# Remand Hearing: LUBA Case No. 2023-001

## Evidence and arguments *against* the Second Assignment of Error

Shannon Hubler  
Felisha Way, Scappoose  
Profession: Stream Ecologist

City of Scappoose  
Remand Hearing: 9/30/24  
Docket # SB-1-22, ZC1-22, Cu1-22, SLDP (1-22, 2-22, 3-22, 4-22)  
Re: proposed development of Buxton property

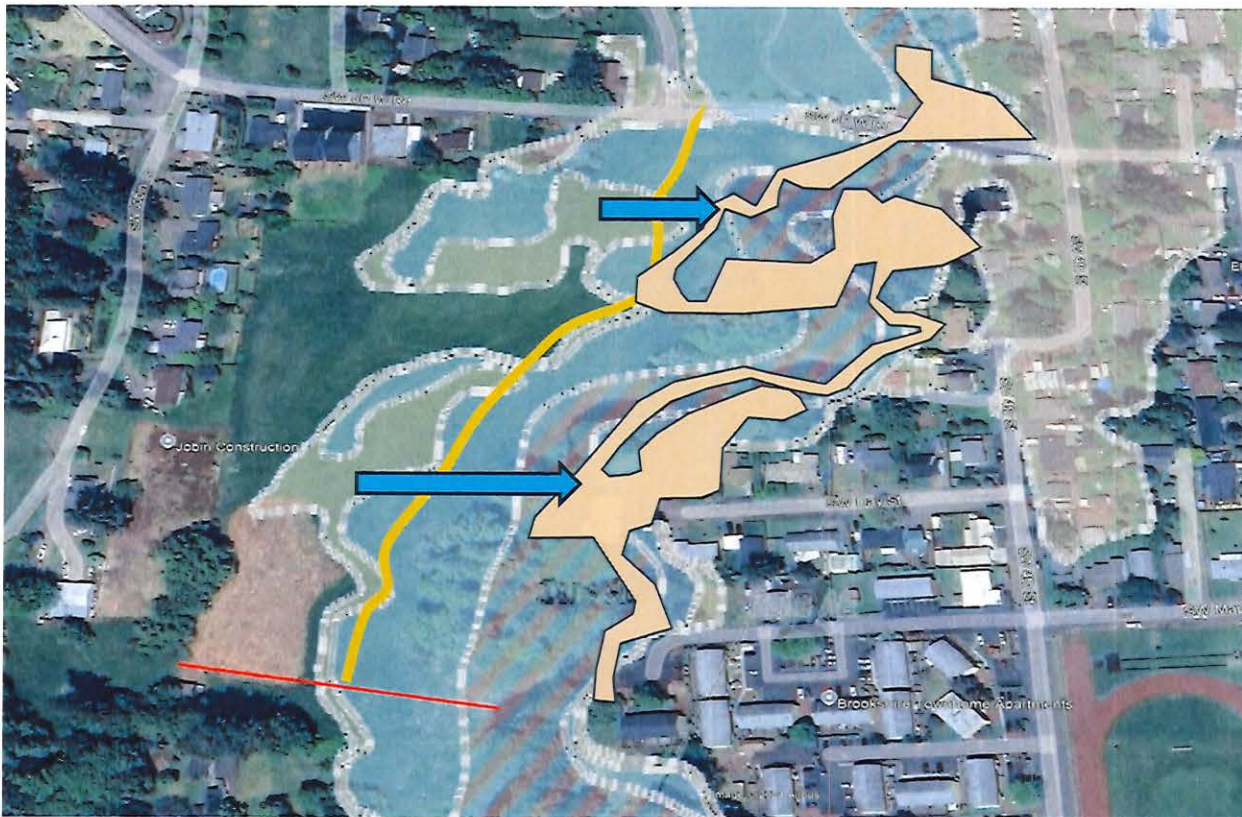
Proposed  
one-sided  
levee

Southern edge of  
proposed Buxton  
development

Using Google Earth and importing flood maps available from FEMA (2024), I was able to coarsely delineate the area listed by FEMA as the 500-yr floodplain. An estimated total of 129,000 ft<sup>2</sup> currently FEMA-identified flood waters will be cut-off by the Buxton levee (Figure 1). Assuming a 1-ft rise in elevations, as identified by Environmental Science & Assessment, LLC (Exhibit 11, [10-27-2022 Planning Commission minutes](#), pp. 266), this means 129,000 cubic feet of flood waters will be cut-off from the Buxton property and pushed to the east and downstream. This increase in flooding

will result in increased flood risks to residents and decreased creek protections to the east and downstream of the proposed development, due to the one-sided levee (Figure 2).

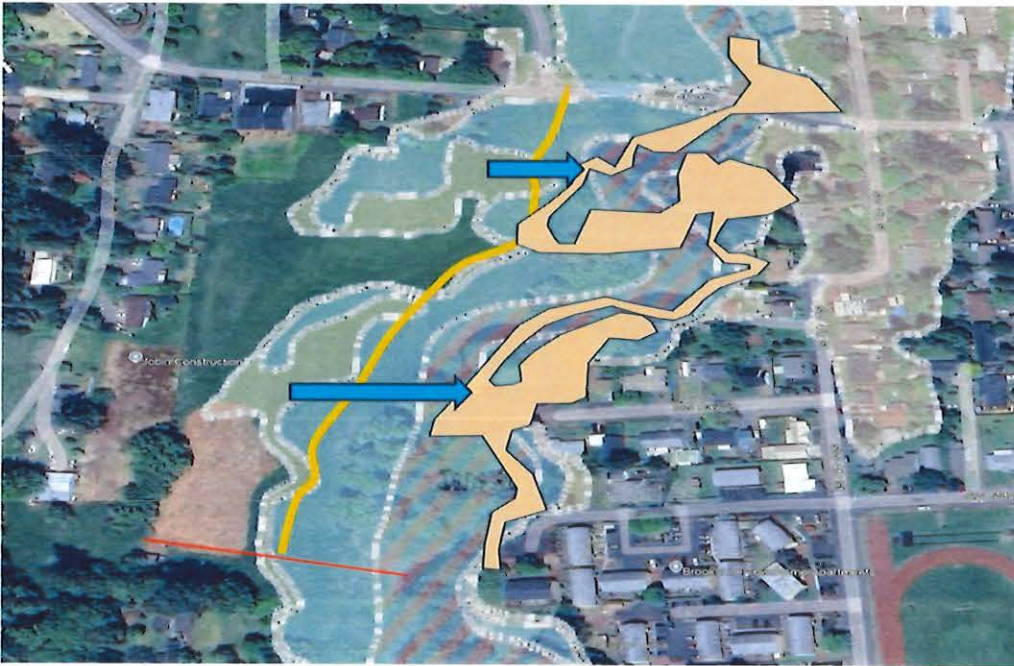
The design for Buxton would effectively build a one-sided levee for a small portion of the South Scappoose Creek watershed. This would without question “shift the flood risk” to other residents. The one-sided levee would also result in decreased creek protections due to cutting off floodplain storage and shifting flood waters away from Buxton and towards the unarmored east bank opposite of Buxton, as well as to unprotected areas downstream. By removing floodplain storage in Buxton, stream flows (i.e., velocities and volumes) will be higher outside of Buxton than if the levee was not in place. Higher velocities bring about increased streambank erosion and channel downcutting (Rosgen 2001, Larsen et al. 2006). Increased erosion and downcutting leads to ecological impacts (i.e., decreased creek protections) including excess sedimentation, decreased water quality, and bank failures.

*Figure 3. The effects of the proposed Buxton Ranch development retaining wall will be to act as a levee and shift floodwaters (above the 100-yr flood) away from the development and into other properties into the vicinity. This represents material detriment to those other property owners.*

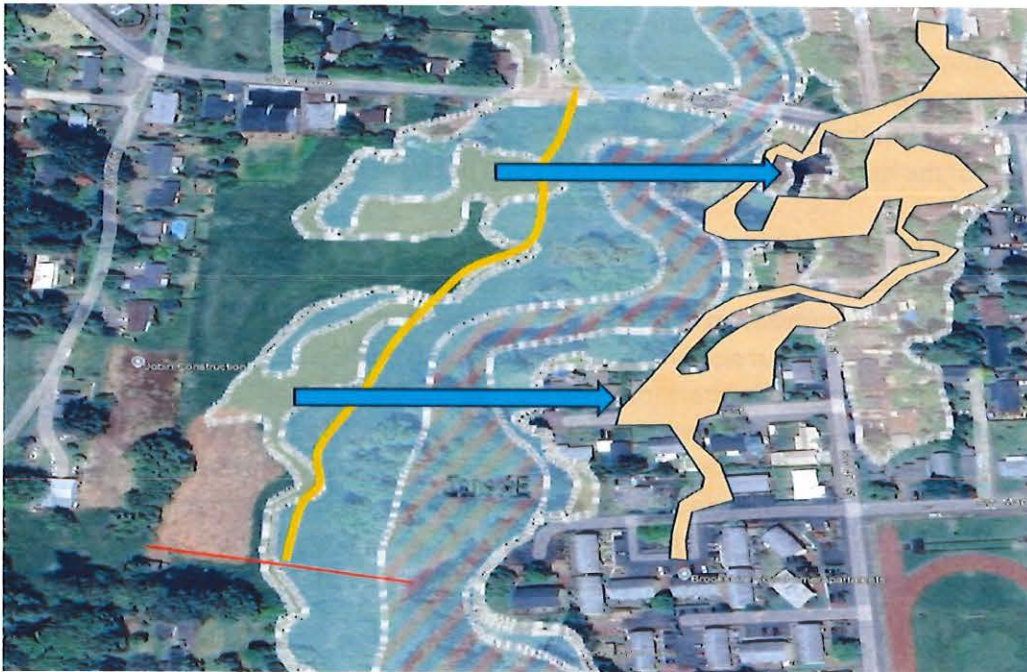
Criteria A states the variance must “not be materially detrimental to...other properties in the...vicinity”. Clearly, the installation of a retaining wall acting as a levee to shift ~ 129,000 cubic feet of flood waters away from Buxton and towards “other properties in the...vicinity” (Figure 3) represents “material detriment” through increased flood damages and likely increased flood insurance rates that would not have occurred without the retaining wall.

In addition, criteria C states “Existing physical and natural systems, such as...drainage...or parks will not be adversely affected any more than would occur if the development were located as specified in the title”. The property is currently zoned as R-1, with a minimum lot size of 20,000 square feet. The City inappropriately approved a major variance by allowing for lots with as little as 4,000 square feet (2,000 square feet below current city minimums), by building a retaining wall that will adversely affect existing natural systems [the creek], drainage [shifting ~129,000 cubic feet of floodwaters], and parks [Chief Concomoly and Veterans parks, immediately downstream of Buxton, will show increased flooding].
